Broadcast Products Technical Bulletin 20-2005-034

DATE: **March 28, 2005**SUBJECT: **CARTRIDGE CANNOT BE DETECTED AFTER
LOADING**

MODEL: **PDW-510
PDW-510P
PDW-530
PDW-530P
PDW-V1**

Figure 1

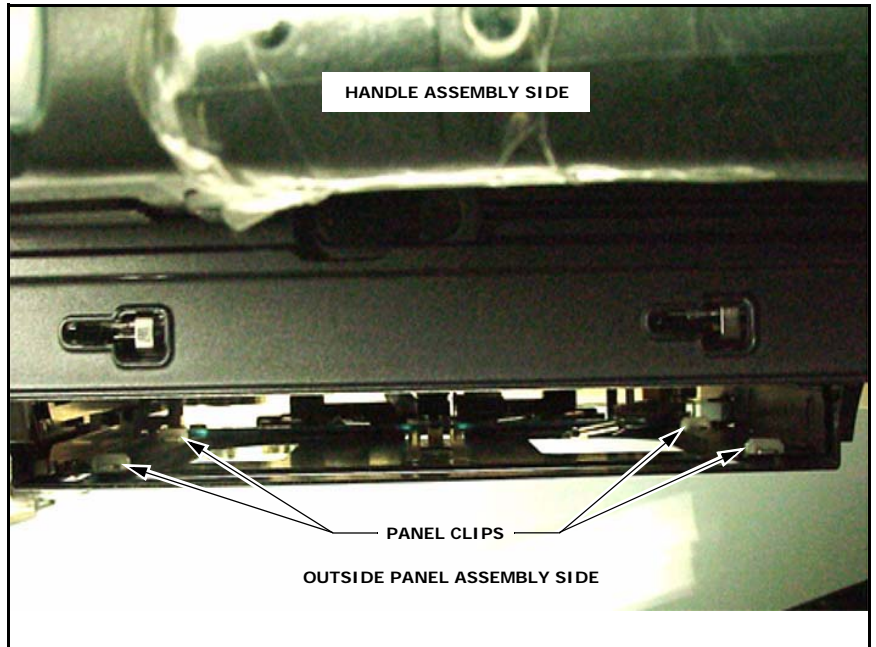
The symptom occurs if the panel clips in the P1 loader assembly are missing. The clips are used to hold the cartridge down.

1. Open the cartridge door of the outside panel, and press the inner shutter down.
2. Confirm that the four panel clips of the P1 loader are installed correctly. (See Figure 1.)
3. If any panel clips are missing, replace the P1 loader assembly (RP) with a new one.

Figure 2

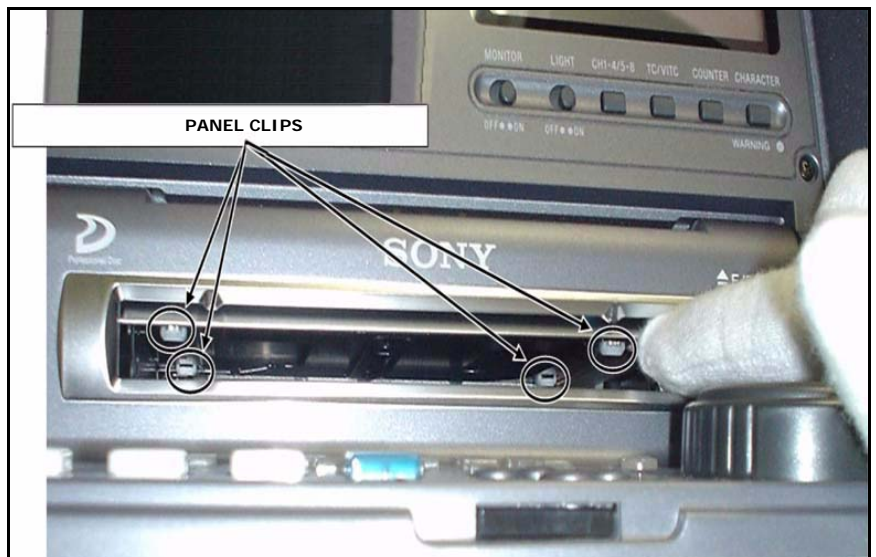
1. Place the unit in the horizontal position.
2. Open the loader door.
3. Illuminate the inside of the loader with a small flashlight, and confirm that the four panel clips of the P1 Loader are installed. (See Figure 2.)
4. If any panel clips are missing, replace the P1 loader assembly (RP) with a new one.
